VTA's BART Silicon Valley Phase II Extension Project

CEQA Addendum to the
2018 Final Subsequent
Environmental Impact Report

Updated/Revised June 2024

Figure 6: 2024 Downtown San José Station Conceptual Site Plan
 VTA's BART Silicon Valley Phase II Extension Project

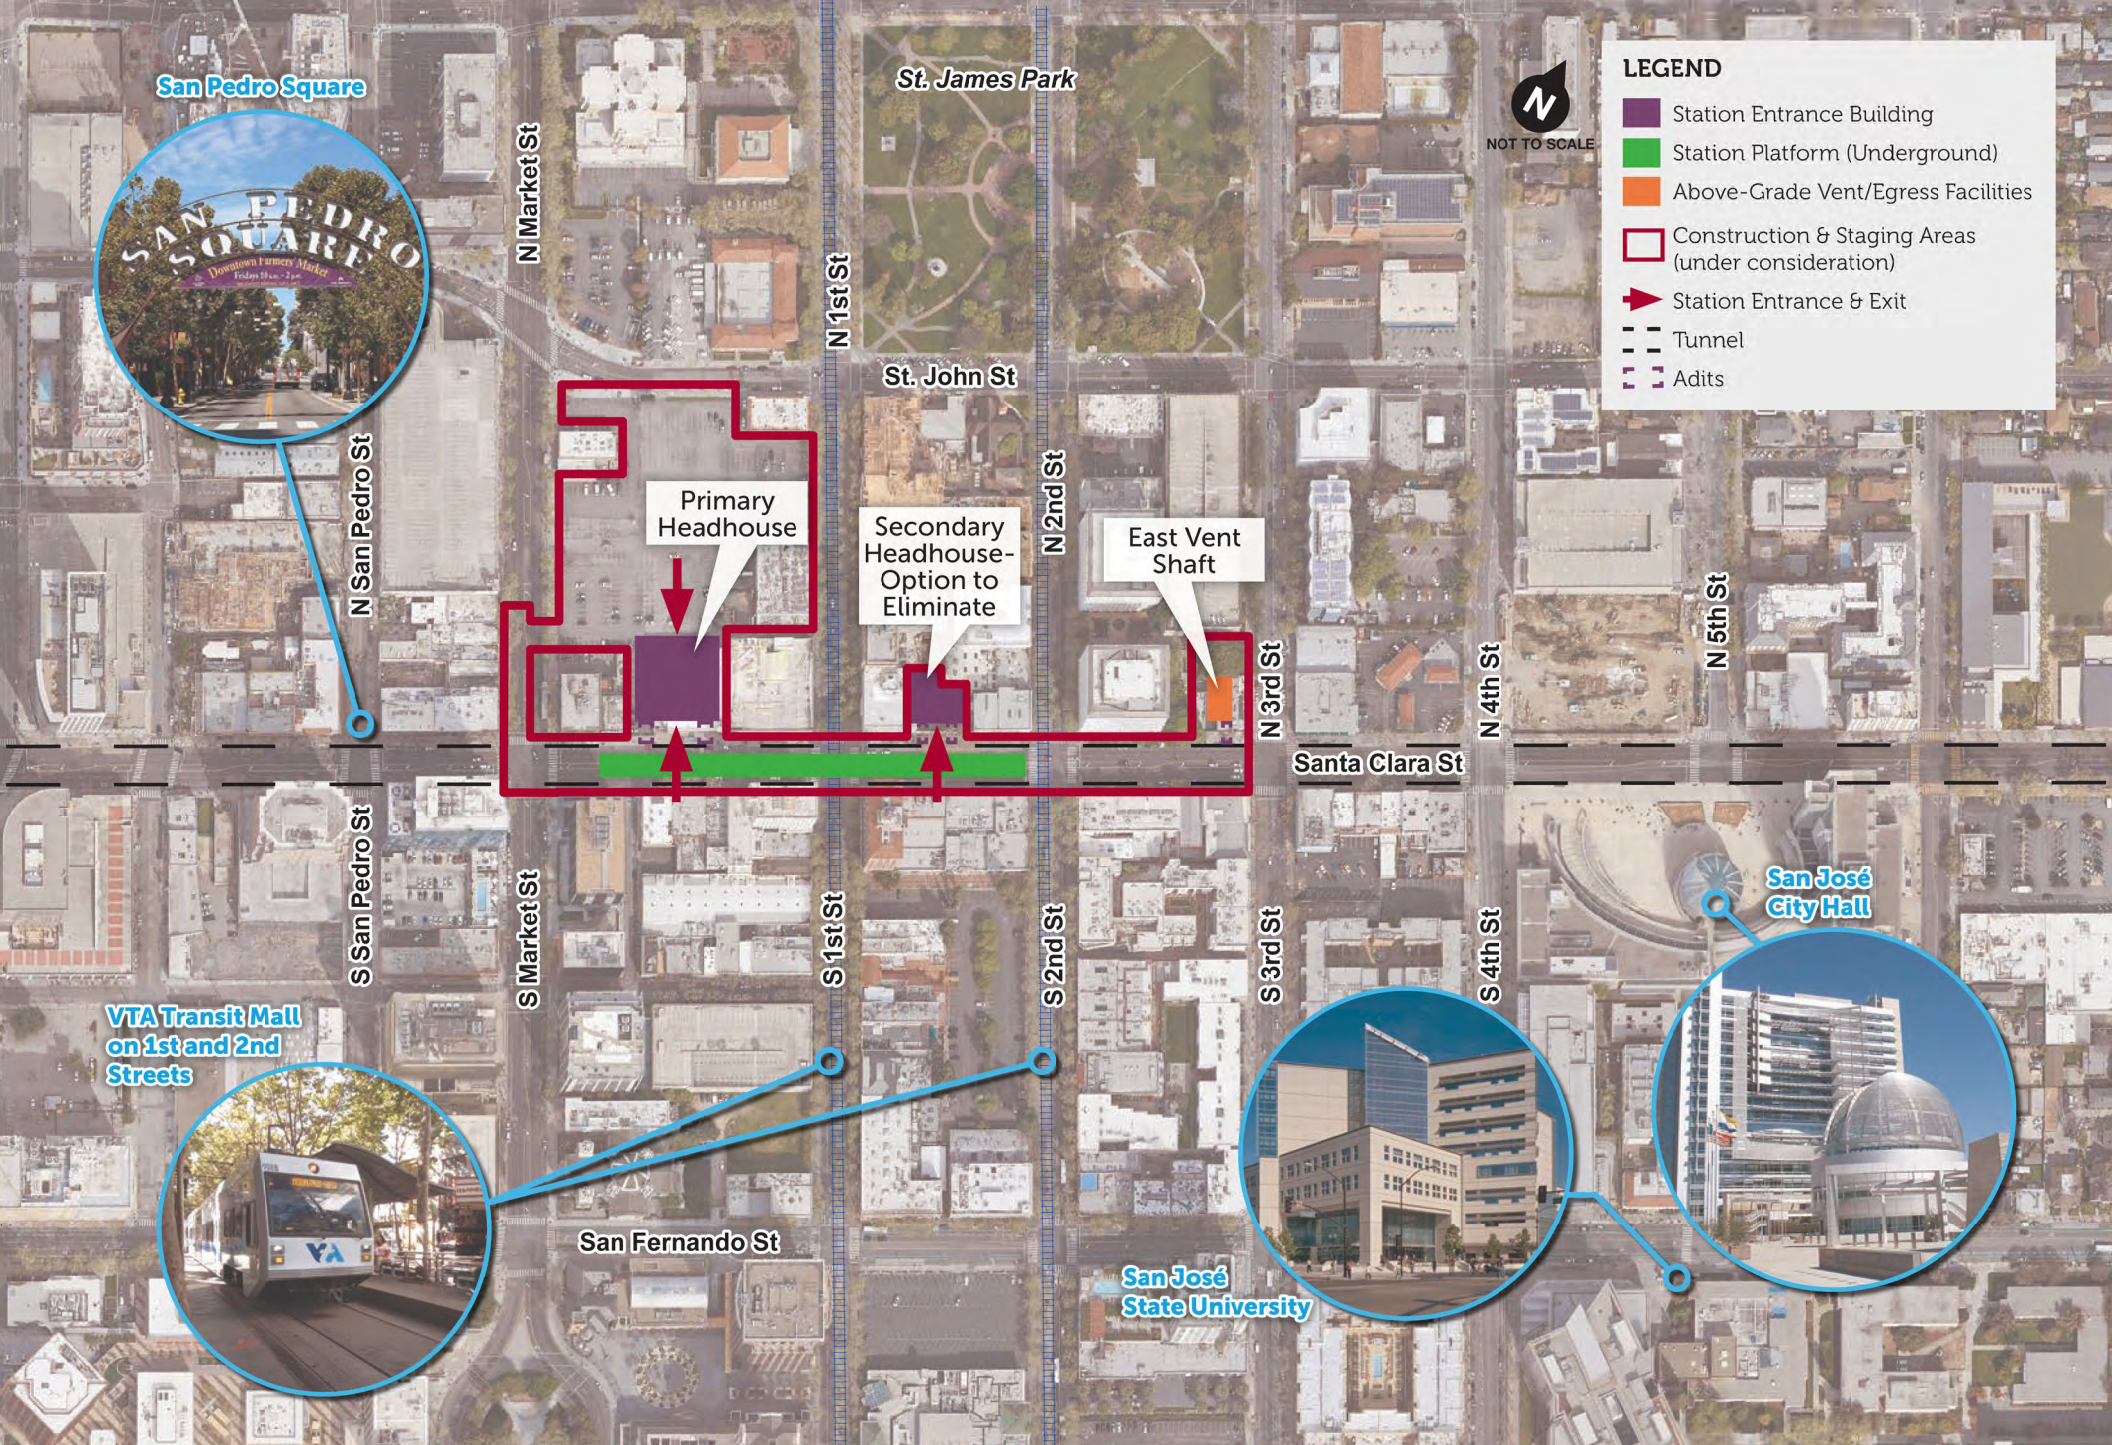
- **Downtown San Jose Station.** This station includes the same project elements in generally the same locations as described in the 2018 Final SEIS/SEIR with the following minor modifications. In the Final SEIS/SEIR, the Downtown San Jose Station included two separate entrance/exit portals located near each end of the station platform. With the updated design, the entrances would be consolidated into a central station building, called a headhouse, that would have multiple street-level entrance/exit points. In addition, the updated design of this station includes an option to eliminate the secondary entrance between 1st and 2nd Streets on the north side of Santa Clara Street. Also, the 0.7-acre construction staging area at the northwest corner of Santa Clara and 4th Streets would be eliminated. Figures 5 and 6 show the previous and updated designs for this station. All design refinements are within the original station footprint.

Figure 8: 2024 Diridon Station Conceptual Site Plan
 VTA's BART Silicon Valley Phase II Extension Project

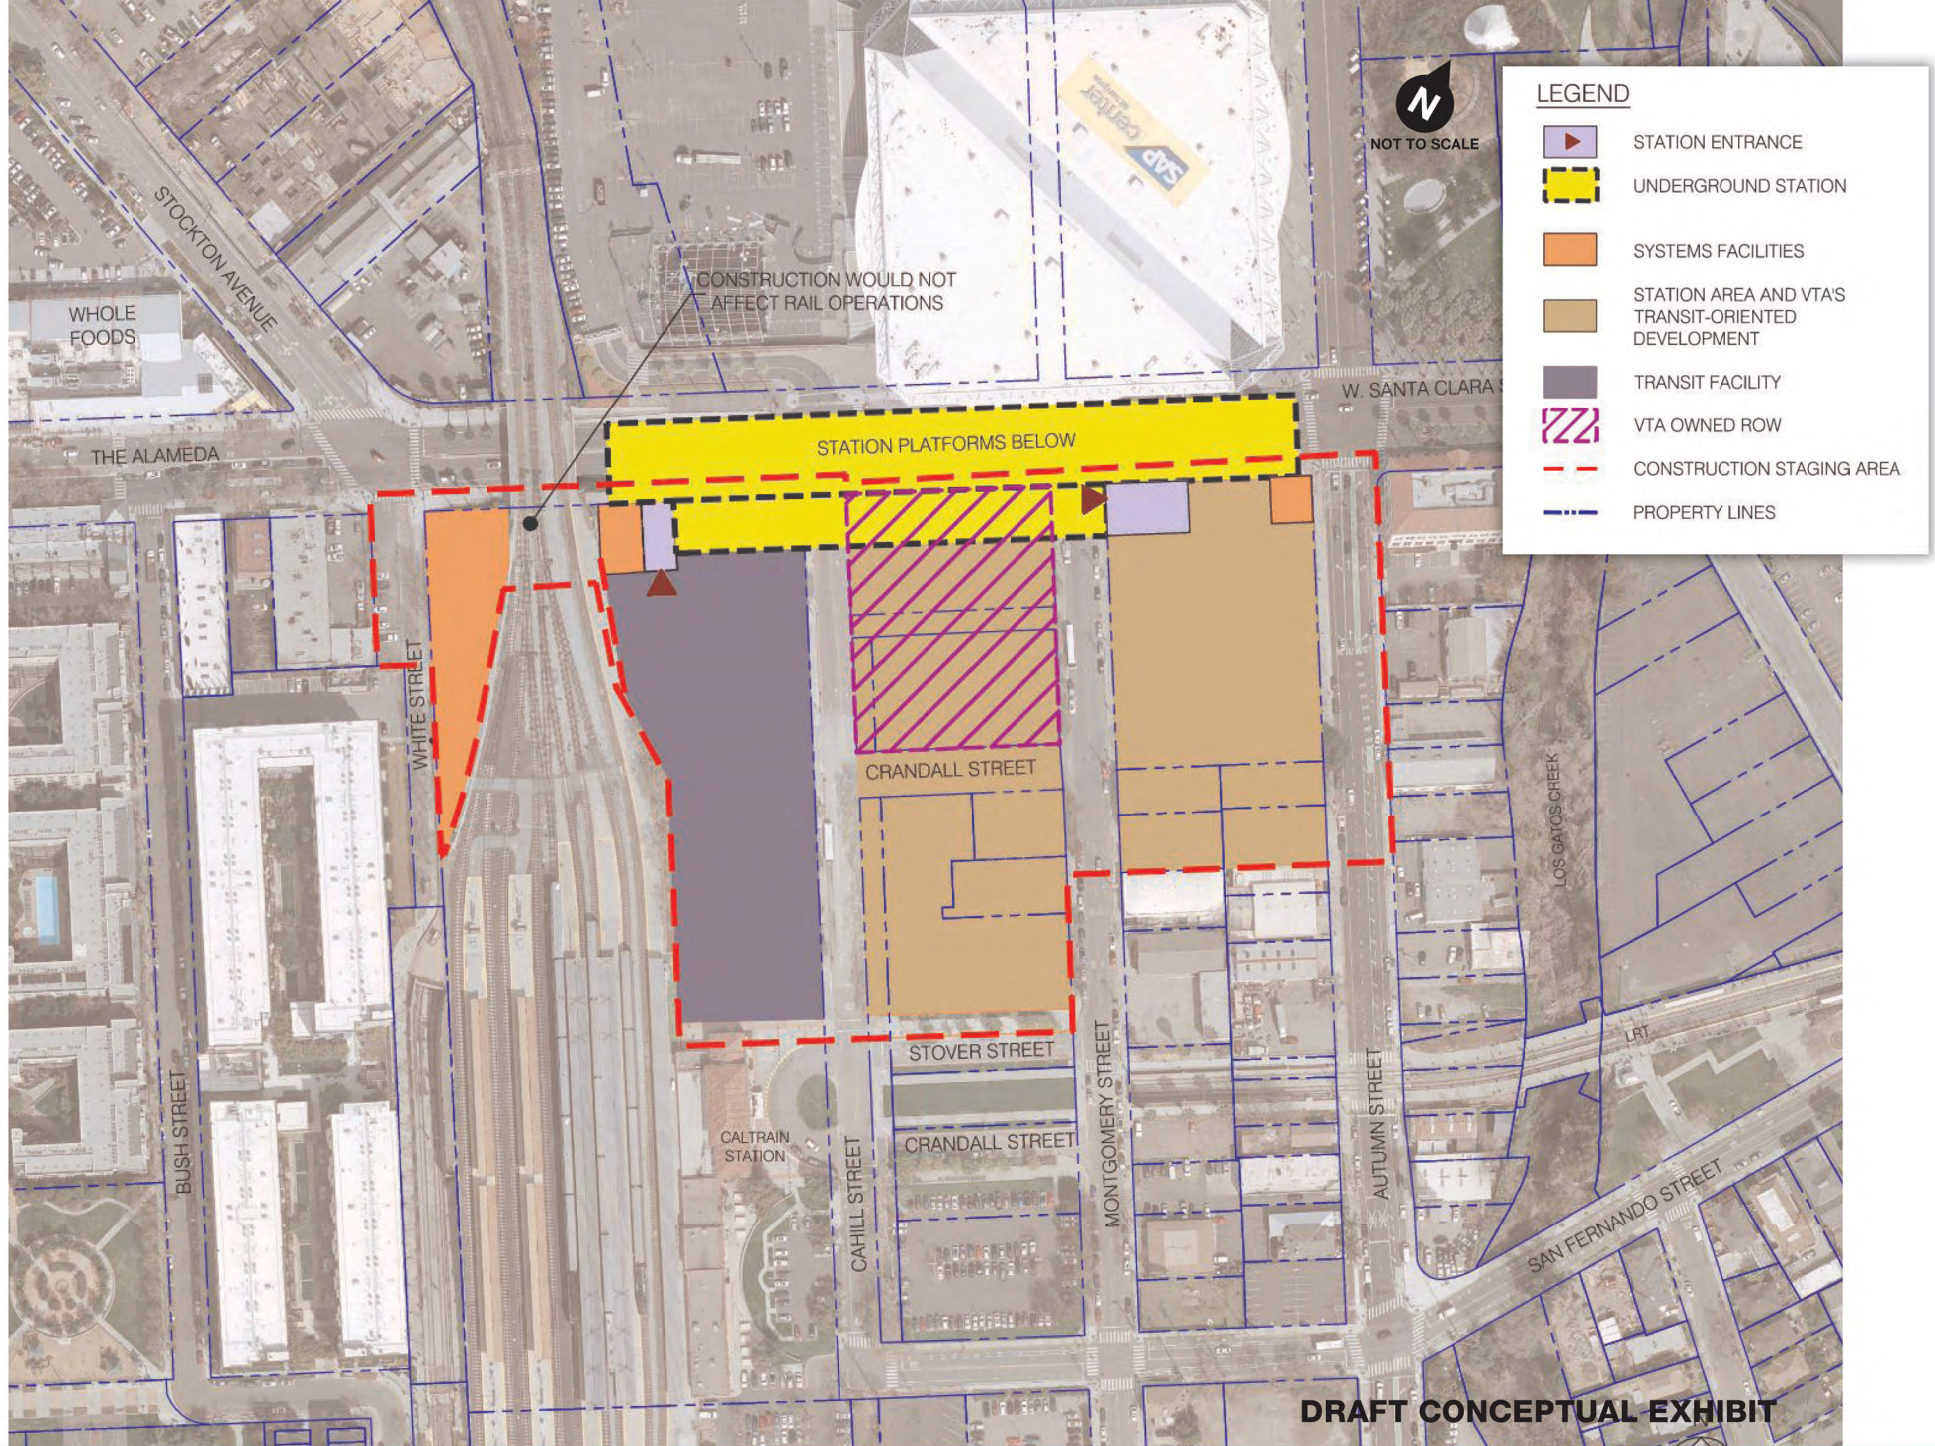
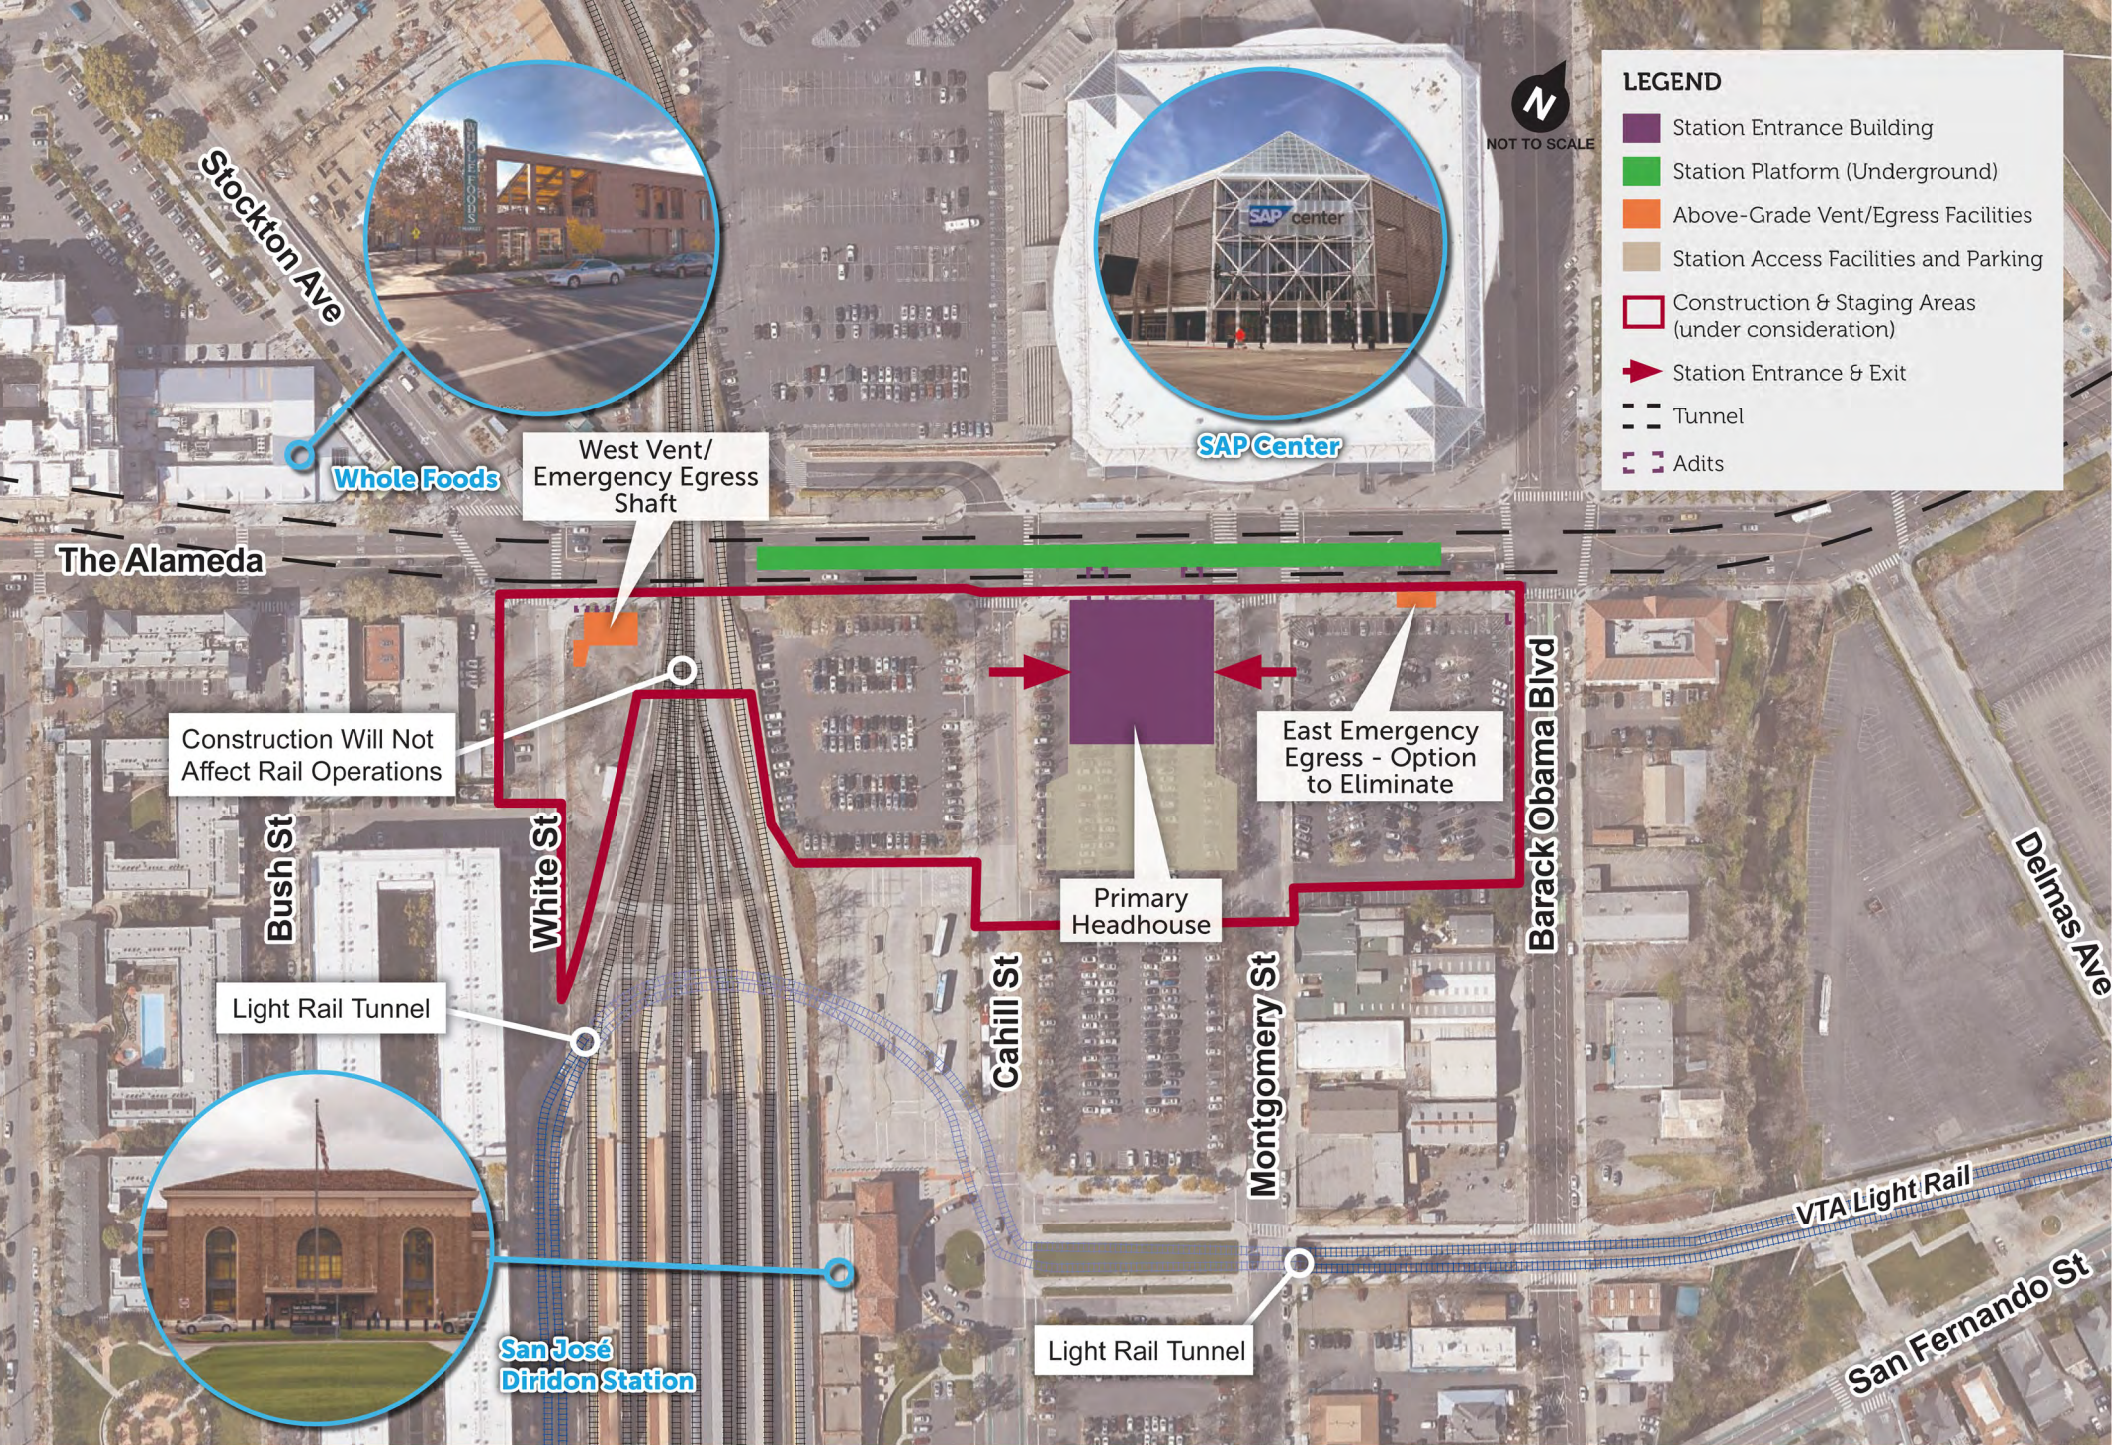
- **Diridon Station.** This station includes the same project elements in generally the same locations as described in the 2018 Final SEIS/SEIR with the following minor modifications. In the Final SEIS/SEIR, the Diridon Station included two separate entrance/exit portals located near each end of the station platform. With the updated design, the entrances would be consolidated into a single central station building that will have multiple street-level entrance/exit points. In addition, the overall footprint of the station would be reduced to 1.5 acres (from 8 acres), and the construction staging areas would be reduced to approximately 5 acres (from 8 acres). The footprint of the station in the Final SEIS/SEIR included the station, system facilities, transit facility, and VTA's TOJD. The footprint of the station in this Addendum shows only the station and system facilities. The updated design of this station also includes an option to eliminate the East Egress Facility at the corner of Santa Clara and Barack Obama Boulevard. Figures 7 and 8 show the previous and updated designs for this station.
